RE: **Lot 37PI – Oxbow Bluff**
5001 Sandpiper NW
Grading and Drainage Plan
Engineer's Stamp Date: 9/19/19
Hydrology File: G11D014H

Re: Lot 37— Oxbow Bluff; Final Review for Lot Specific Grading and Drainage Plan

GRADING AND DRAINAGE PLAN

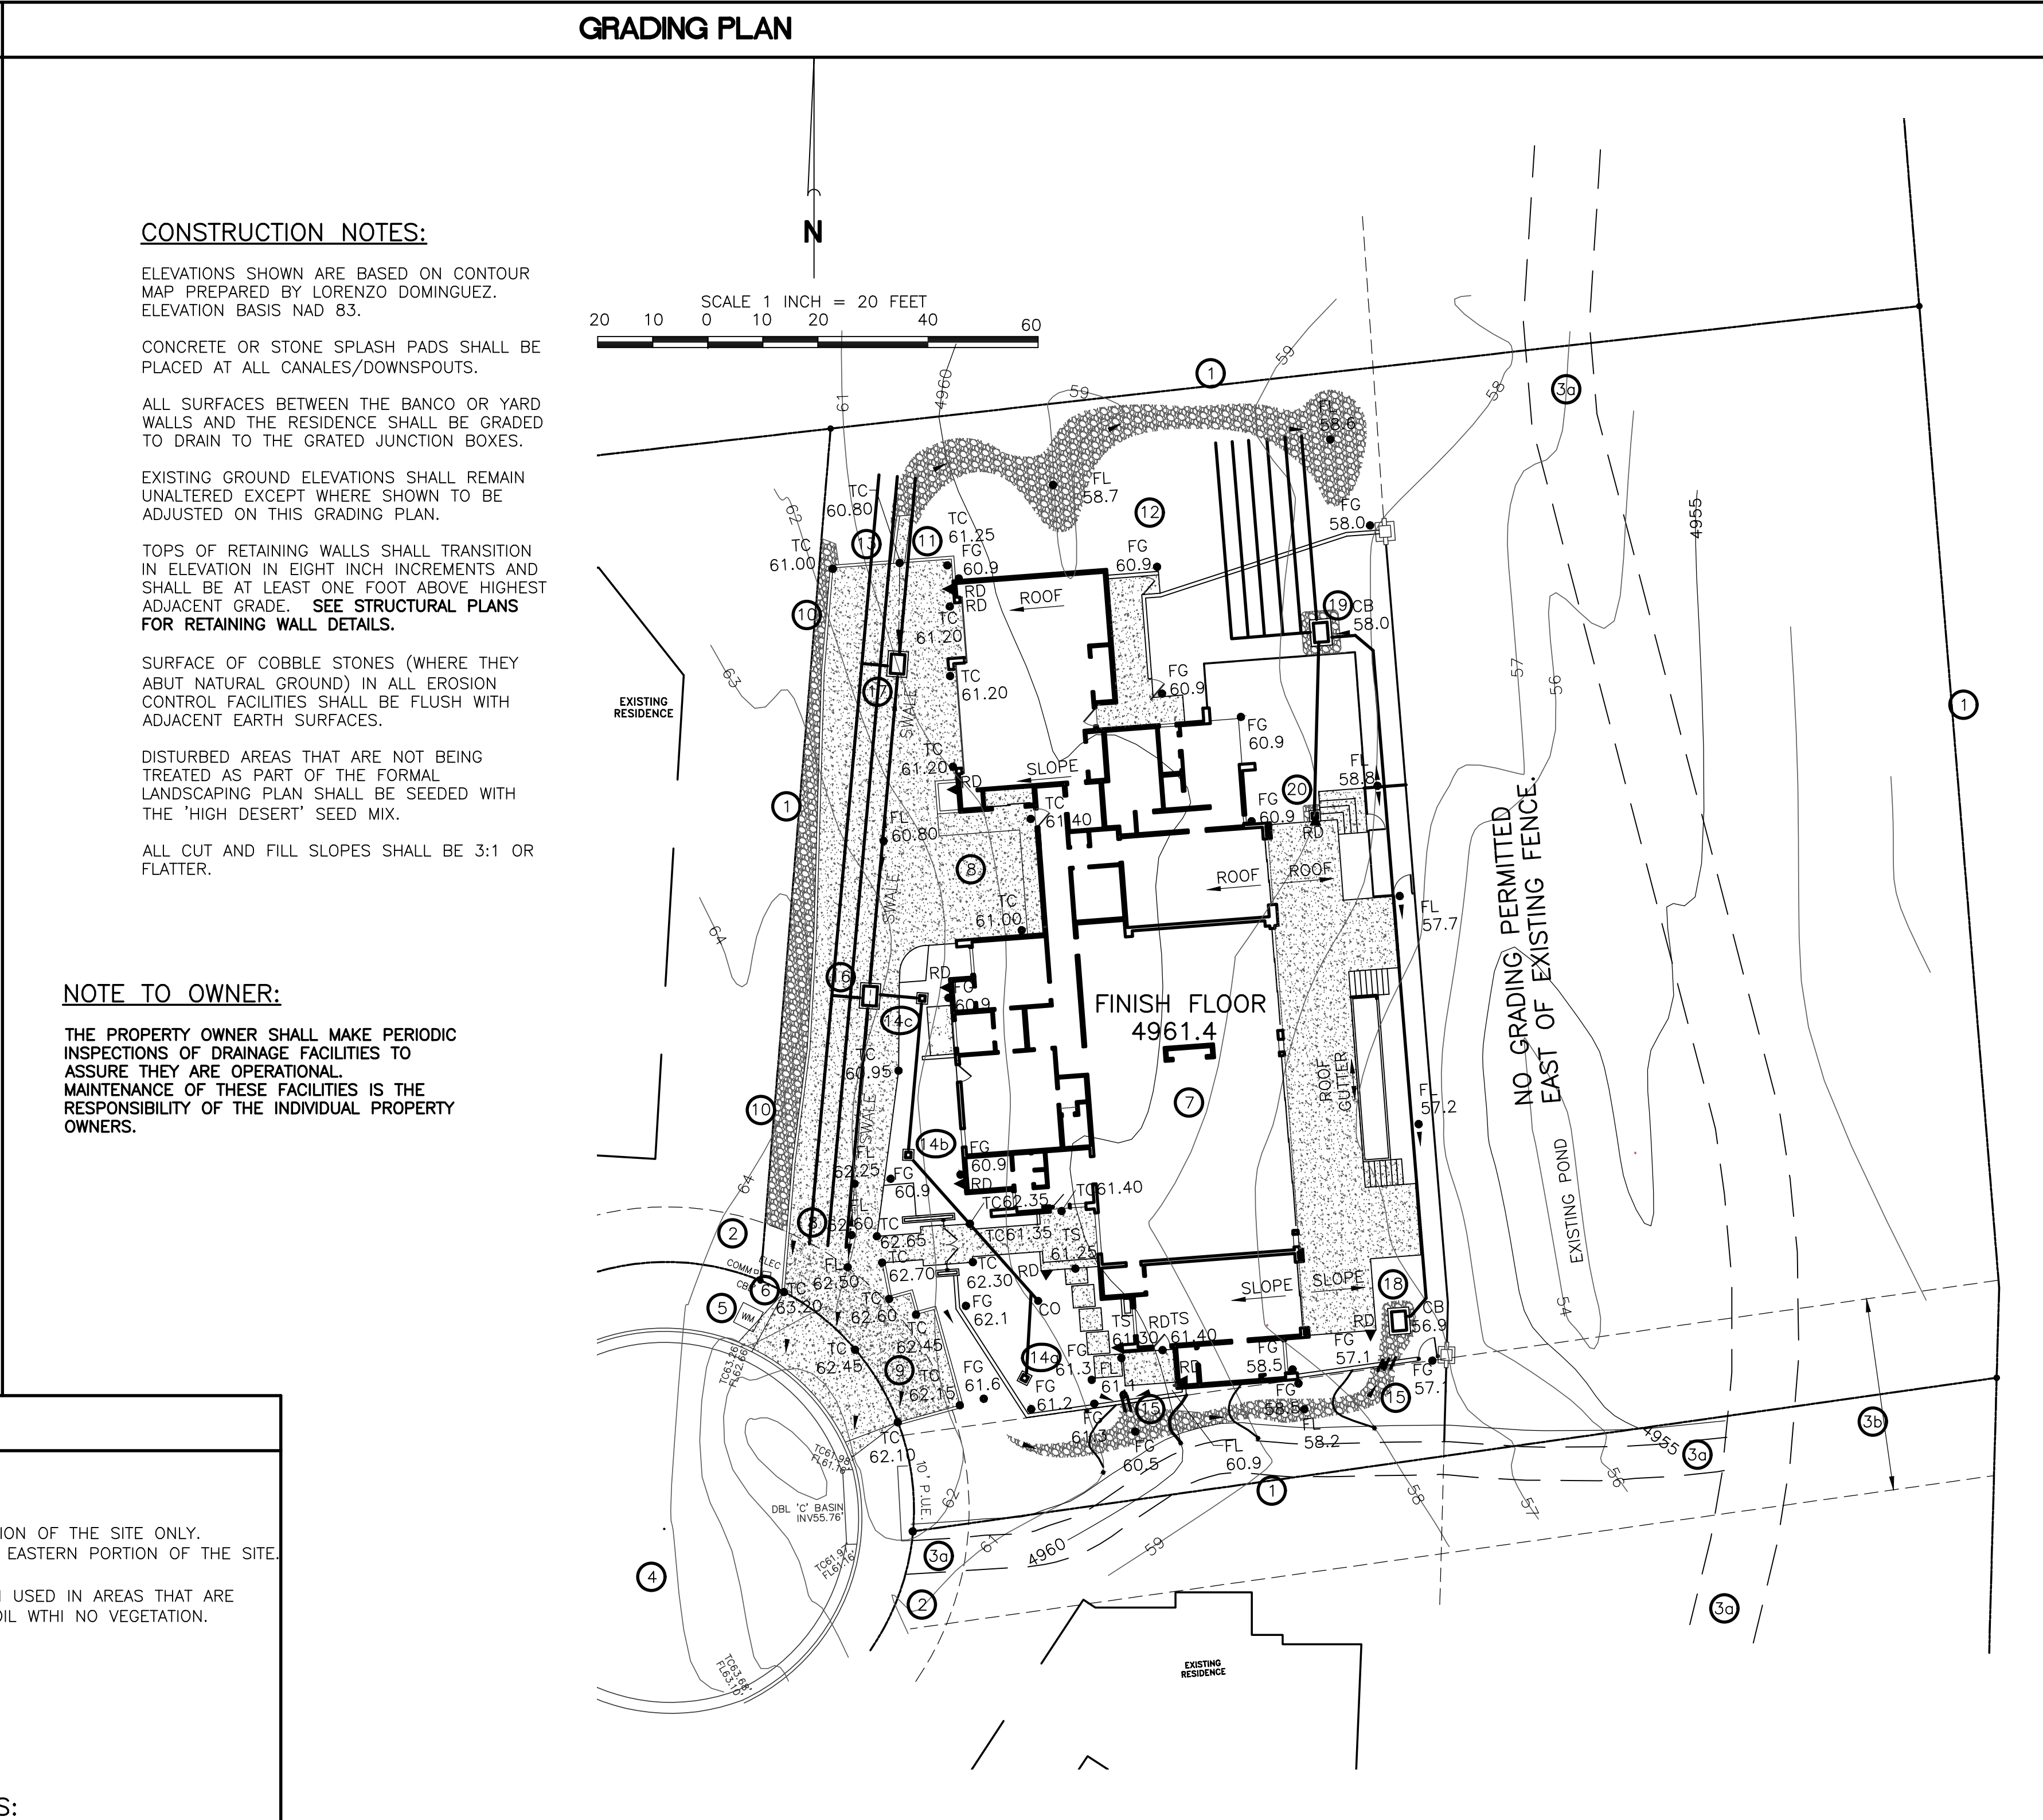
Based on the revised grading and drainage plan for the above referenced Lot stamped dated 9/19/19 by Jake Bordenave, it appears that all the comments have been addressed in regard to the grading and drainage. The approved plan is attached for reference.

Based on the submittal received on 10/17/19, the Grading and Drainage Plan is approved for Building Permit.
